OFFICE OF ENERGY INFRASTRUCTURE SAFETY

Erik Takayesu Vice President Asset Strategy and Planning Southern California Edison 2244 Walnut Grove Rosemead, CA 91770 NOV SCE ATJ 20211209-01 Revised

NOTICE OF VIOLATION

Report Name: ATJ_SCE_20211209-01_Revised

Structure ID: GT5560

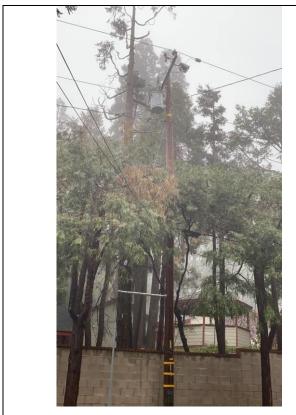
Item7GW2Img1: Vegetation touching guy wire above insulator

Structure ID: 1763105E

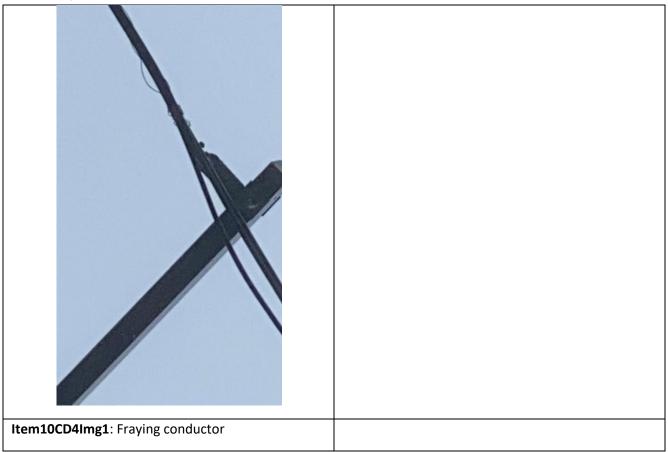
Item10IA1Img1: No covered conductor installed

Structure ID: 1414393E

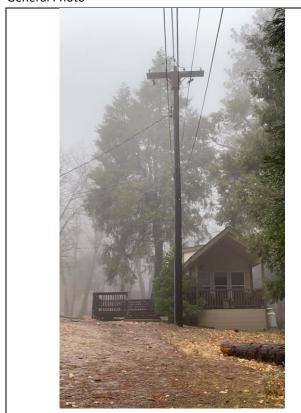
Item11IA1Img1: No covered conductor installed
